**REVIEW OF DOCUMENTATION &
REPORT RE FOX STUDIOS
CRAFT SHOP:
AIR QUALITY CONSIDERATIONS**

Prepared By:
Child & Associates

Prepared For:
**Office of Clover Moore MP
Member for Bligh**

**AIR QUALITY IMPACT ASSESSMENT
BUILDING 34, FOX STUDIOS**

Figure 5

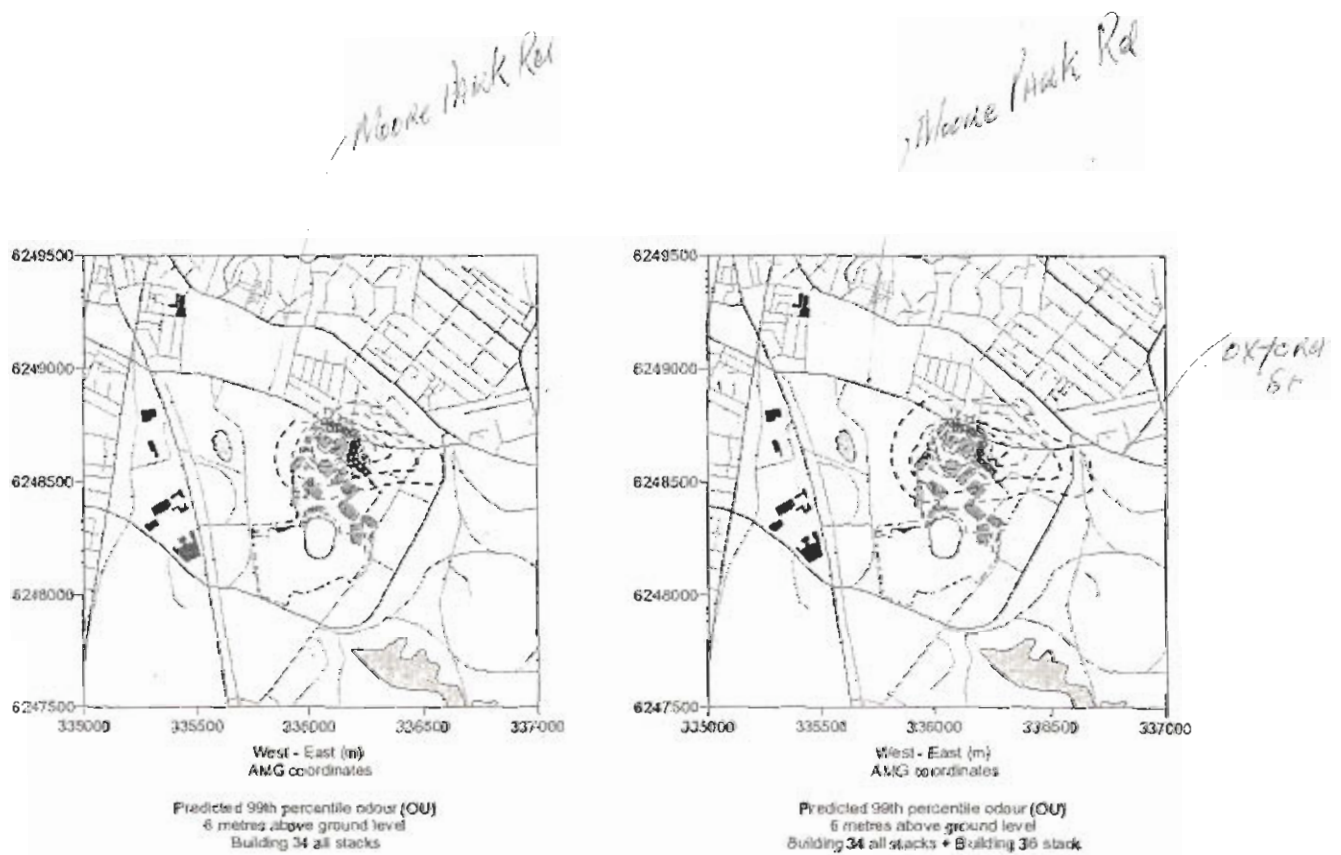
PARADISE NOTE NECS DYEROOM is issue - Has little Ventilation No EMISSION CONTROL
Figure 5 presents the predicted impacts of emissions from all four vents on building 34 and the cumulative impacts with building 36.

What are they to reveal chemical - Toxic - HAZARDOUS - etc?
There are predicted exceedances of the 99th percentile 2 odour unit goal outside the site.

Figure 6

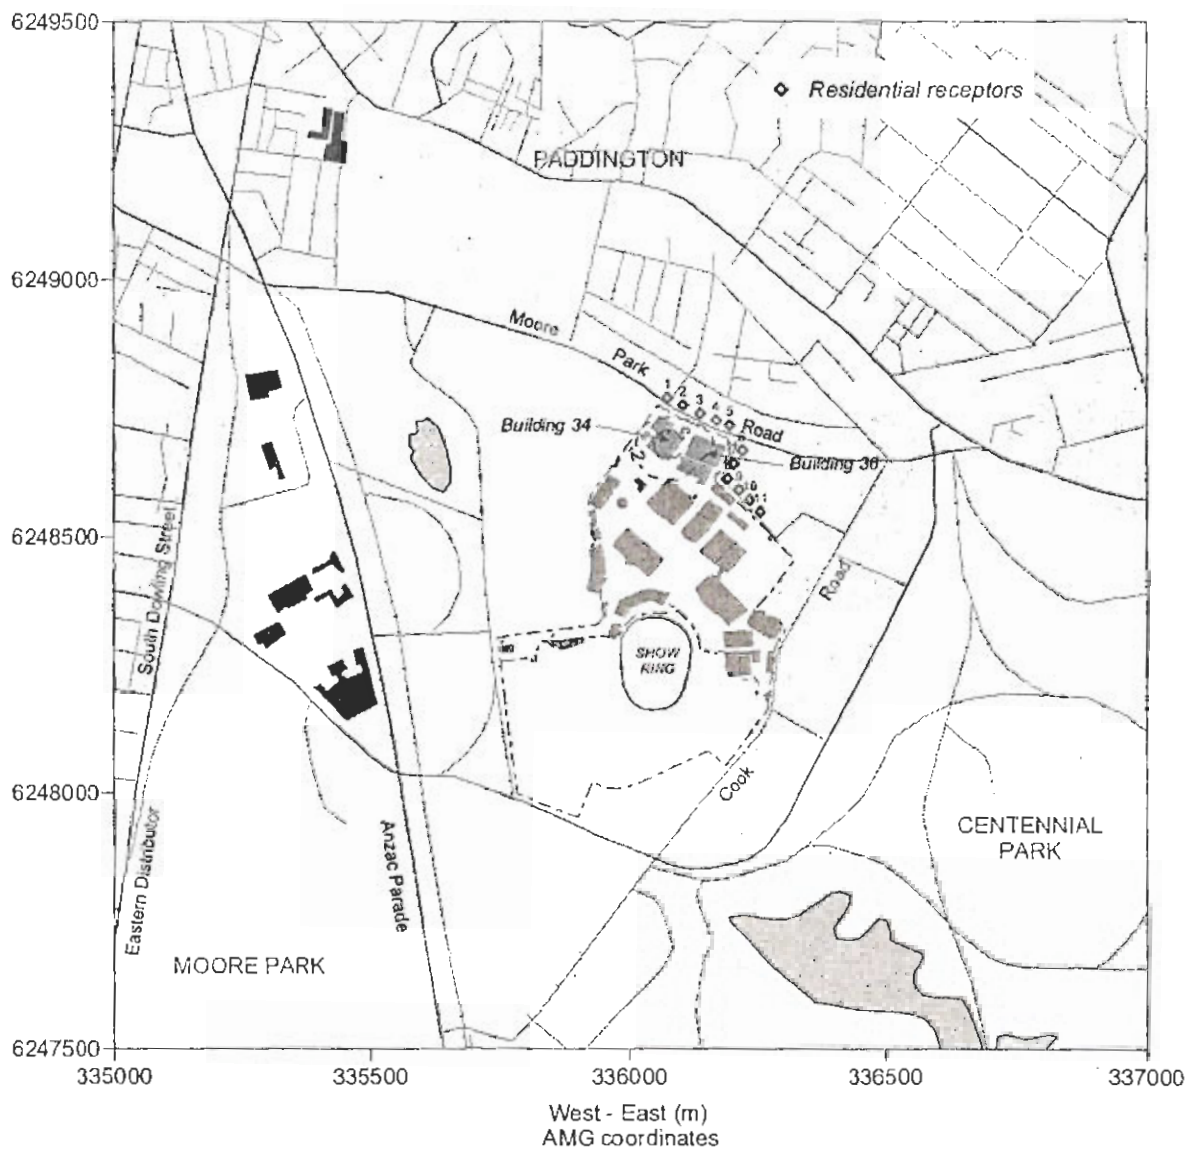
Figure 6 presents the predicted cumulative odour impacts at the 99th percentile for building 34 with 90% control of odour and building 36. It has been assumed that the odour emissions from building 34 would be controlled by 90%, that is the odour emission rate would be 244 ou.m³/s. The predicted odour impacts are below 2 odour units at all sensitive receptors. *only? wow thanks*

*Note: There Are No Examples of A N/NE Wind (Summer)
Heading over over Annis Stadium or Cricket ground
And Bent St. Why?*
